# XFEL DAQ infrastructure meeting

WP76

Minutes of the 21<sup>st</sup> May 2008 meeting (Revised 22.5.2008)

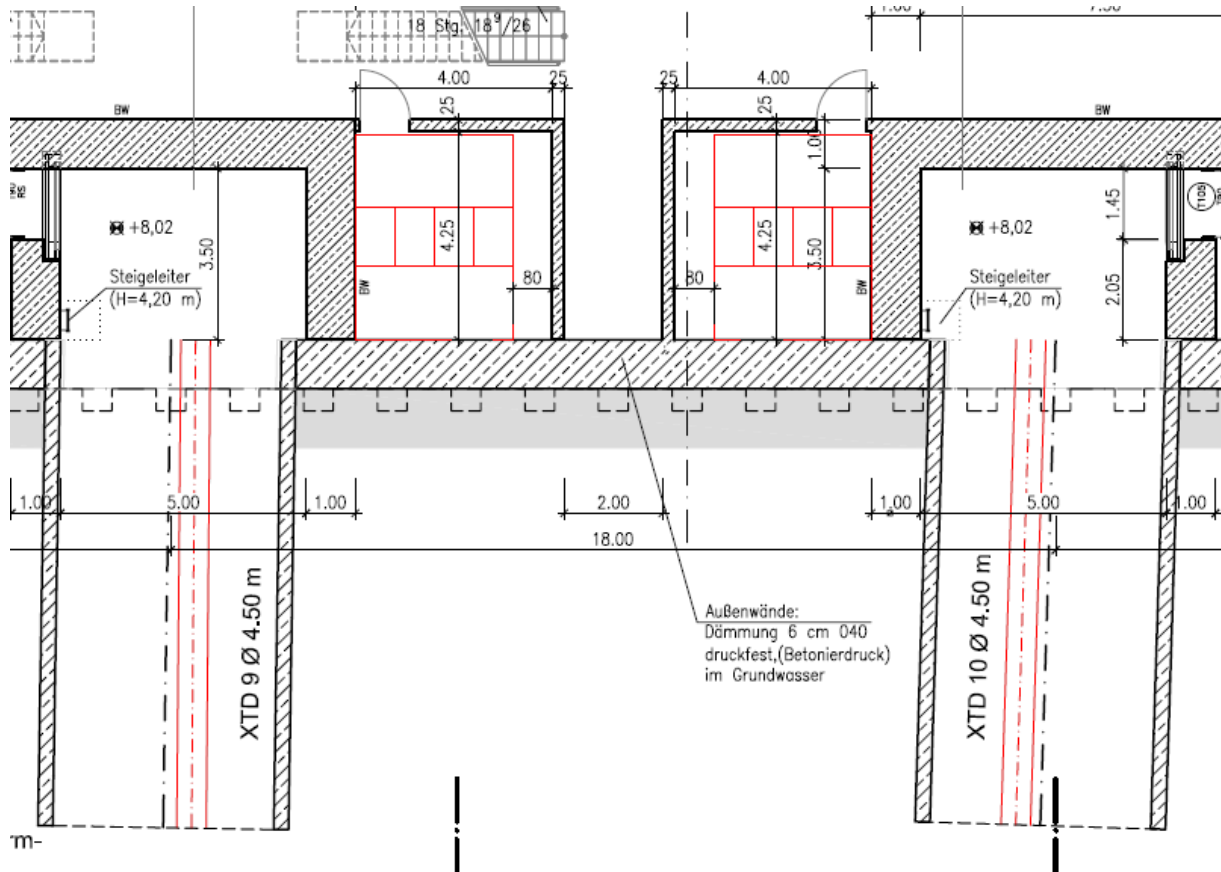
The foot prints, in red, have been added to the official drawing of the hall experimental area, see below.

The zoom below shows that the footprints have been placed in separate walled off areas.

Note that the hatch to end point connection route will be specified later.

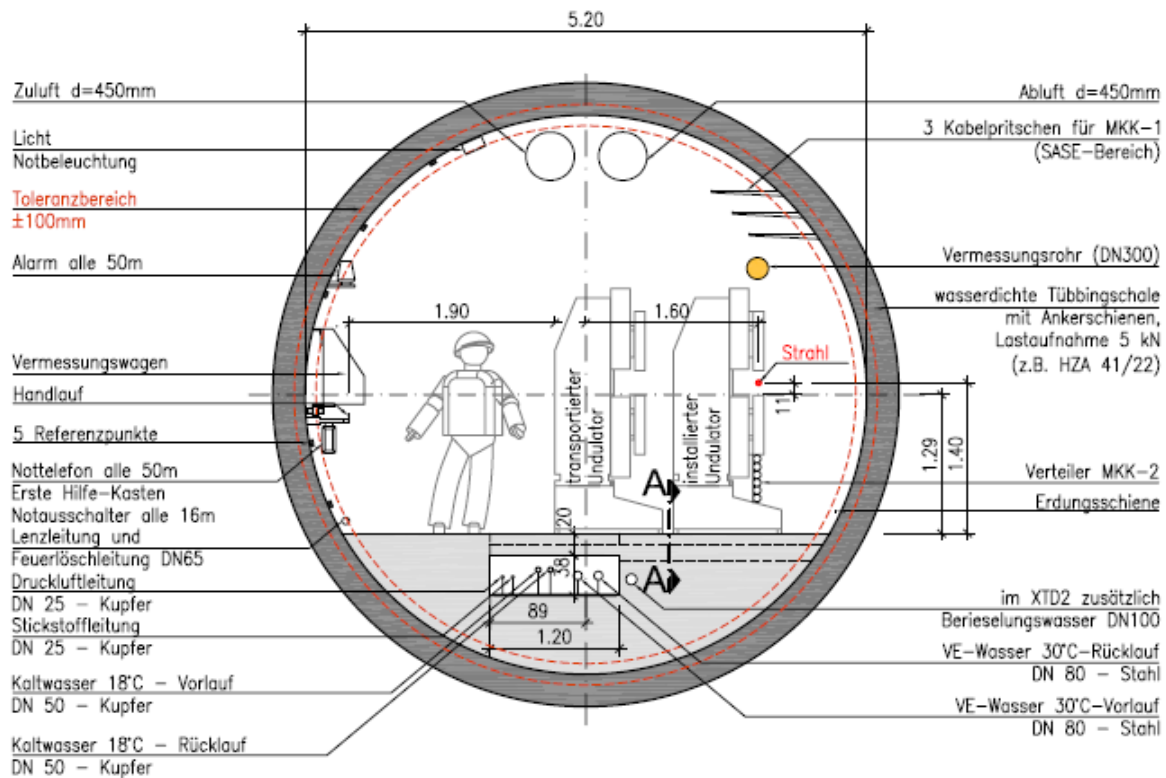
Following the last meeting it was discovered that 3 cable trays have been foreseen in the photon beam line tunnels. These appear to be associated with the undulator installation and probably run from XS1 to the last undulator section in each beam line – **confirmation is required**. The trays are visible in the drawing of the XTD1 undulator tunnel cross-section below.

Two cable trays are allocated for use with undulator power and undulator control network cables. The third was allocated for power cables associated with the quadrupoles of the phase shifters, but as these now use permanent magnets the cable tray **may be free ask**.

Note that cooling water pipes are shown in the underground conduit; **are these only in the undulator section of the tunnel; are they available for use in the rest of the photon tunnel**, e.g. by the beam line systems?
